**UPT-6011**

# Replacement instruction

The new CIRUS temperature controller UPT-6011 (after date of manufacture 04/2016) was fitted with a more powerful processor to enable new functionalities. Furthermore new features and interfaces were integrated and an approval for the American and Canadian market is existing. The UPT-6011 in his actual version is downwardly compatible to the previous models, except the terminal assignment. Thus it is possible to integrate the controller as an alternative in existing machines.

# Wiring diagramm of the UPT-6011

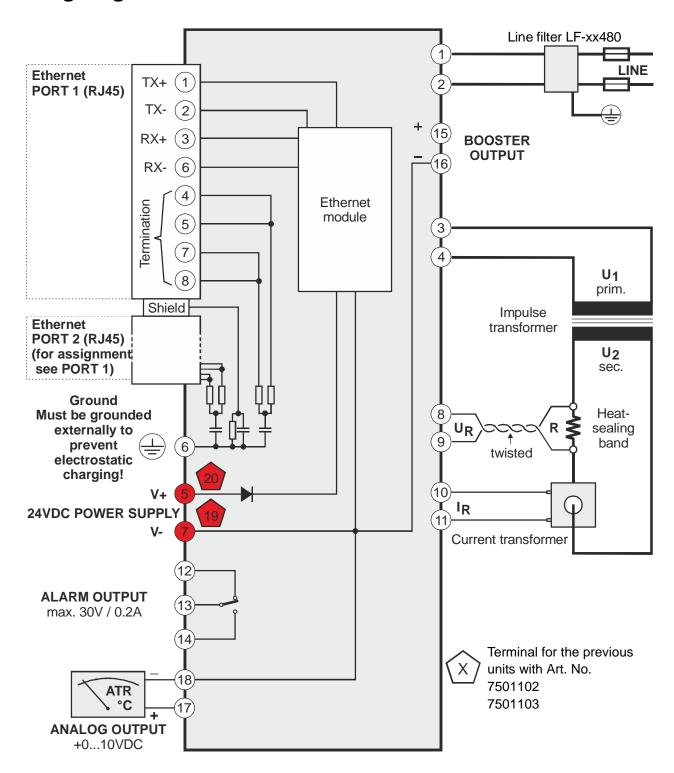
The 24VDC supply voltage were laid from the terminals 20 and 19 to the terminals 5 and 7. The separate 2-pin terminal block (for pin 19 and 20) therefore no longer exists.

The terminal block for the power supply (pin 1 to 4) is UL-listed and mechanically no more compatible to the previous terminal block. However the terminal assignment remains unchanged.
